PRAIRIE ISLAND NUCLEAR GENERATING PLANT UNIT NO. 1

AMENDMENT TO FACILITY OPERATING LICENSE

Amendment No. 18  
License No. DPR-42

ATTACHMENT TO LICENSE AMENDMENT NOS. 18 AND 12  
FACILITY OPERATING LICENSE NOS. DPR-42 AND DPR-60  
DOCKET NOS. 50-282 AND 50-306

# PRAIRIE ISLAND NUCLEAR GENERATING PLANT SITE LAYOUT

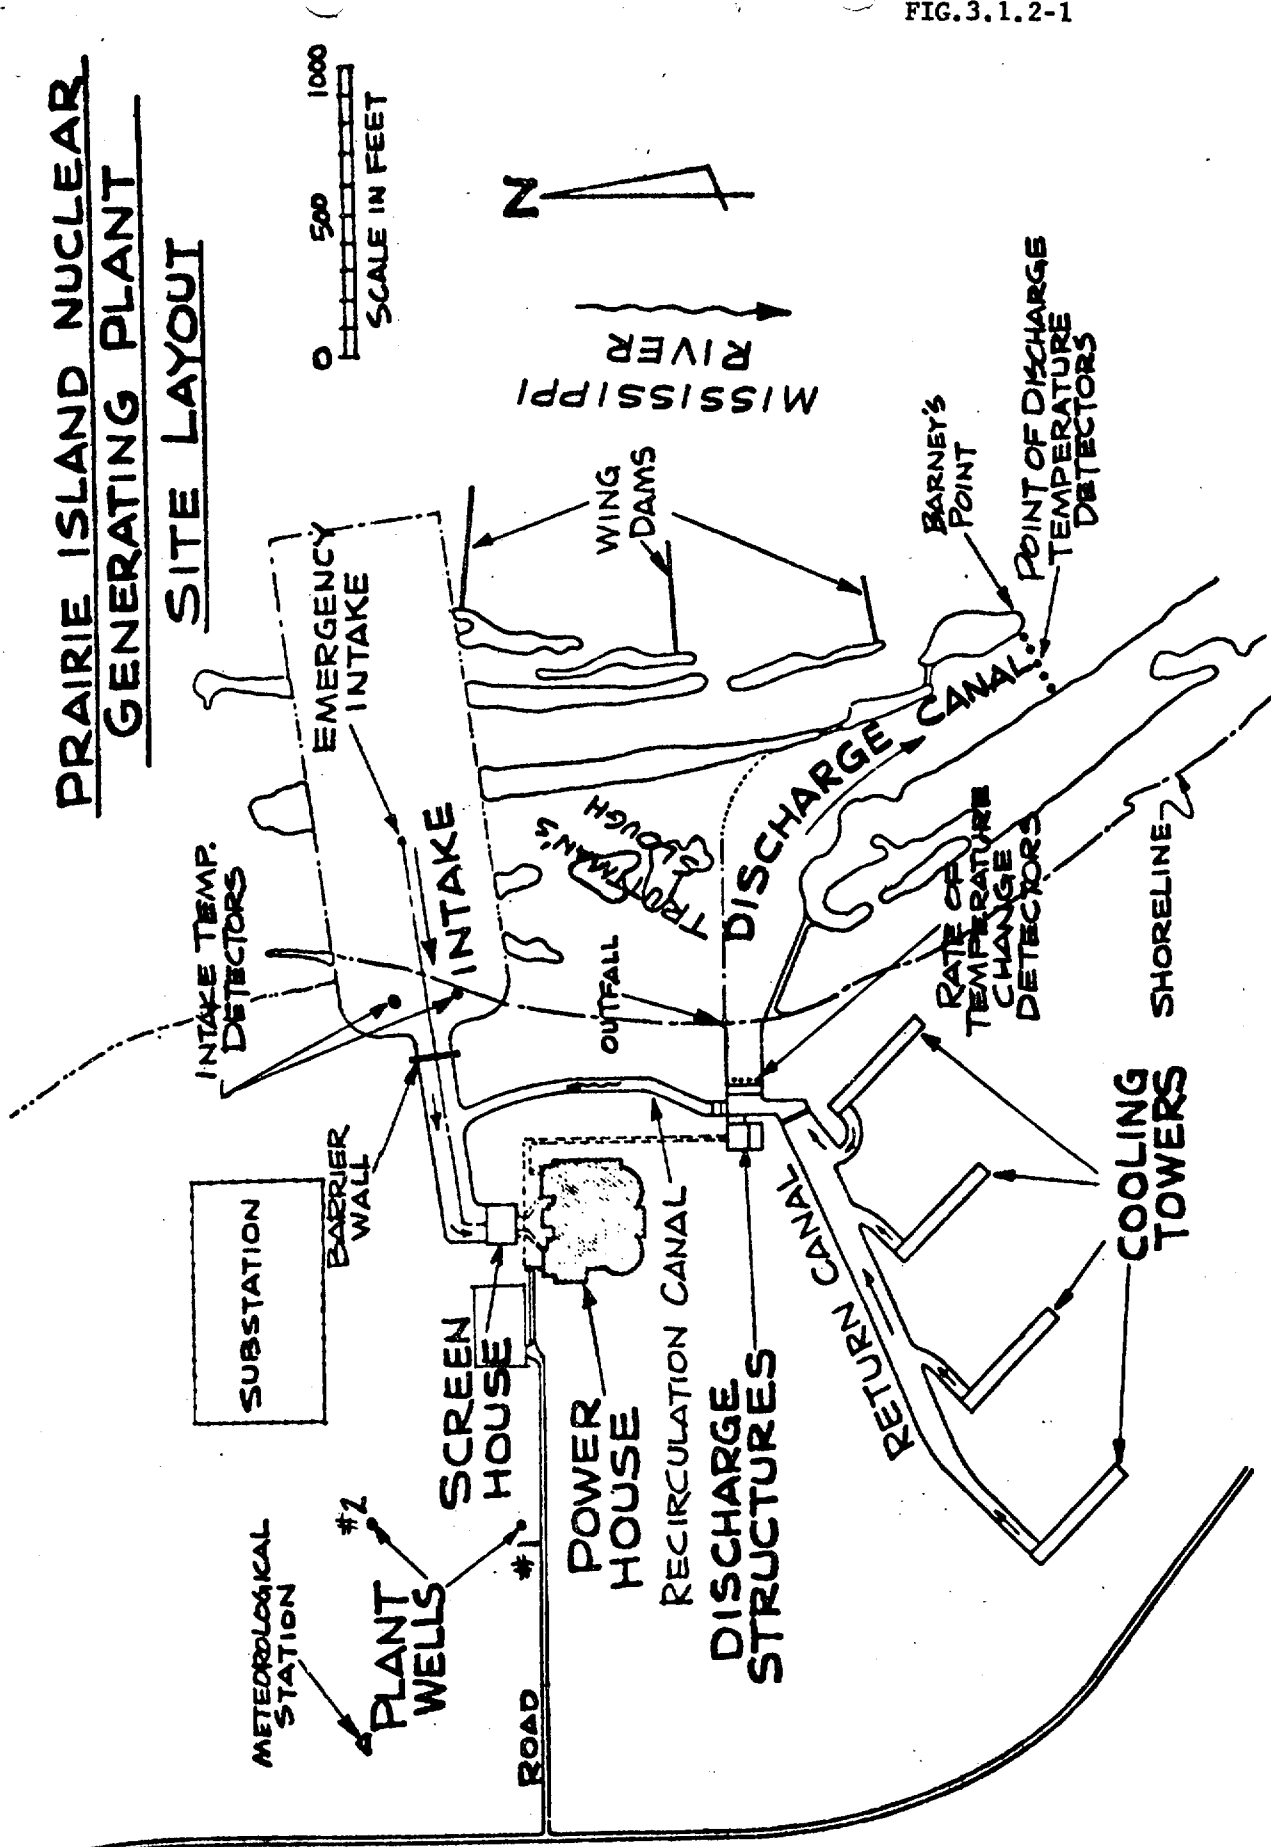
- C. Discharge Canal: That portion of Truttman's Slough starting at the outfall and extending East and Southeast to the temperature detectors located at Barney's Point (Figure 3.1.2-1).

- D. Point of Discharge: Downstream end of the discharge canal.(Figure 3.1.2-1)
- E. Outfall: The shoreline location where effluent water flows into Truttman's Slough as indicated on Figure 3.1.2-1.

Specification: The ambient river water temperature shall be measured by a minimum of two temperature detectors located upstream of the barrier wall (Figure 3.1.2-1). The discharge temperature shall be measured by a minimum of two temperature detectors located at the end of the discharge canal. The locations of the detectors and functioning of the temperature monitoring system shall be established and verified annually thereafter to assure that monitoring results are representative of flow-weighted average temperatures and temperature differences for various modes of operation.

Basis: The ambient intake temperatures are measured by eight resistance temperature detectors (RTD's) connected to the plant computer. Four RTD's are mounted at each sampling location as shown in Figure 3.1.2-1. The RTD's are spaced two (2) feet apart from elevation 672.5 to 666.5 on each sampling pile assembly. Each RTD is scanned every minute by the computer. A five-minute average of the eight RTD measurements is calculated. Every hour the average of the eight RTD's is computed for an hourly average ambient river water temperature. If the computer is not functioning for more than one hour, at least two RTD measurements will be recorded and used to calculate the hourly average ambient river water temperature.
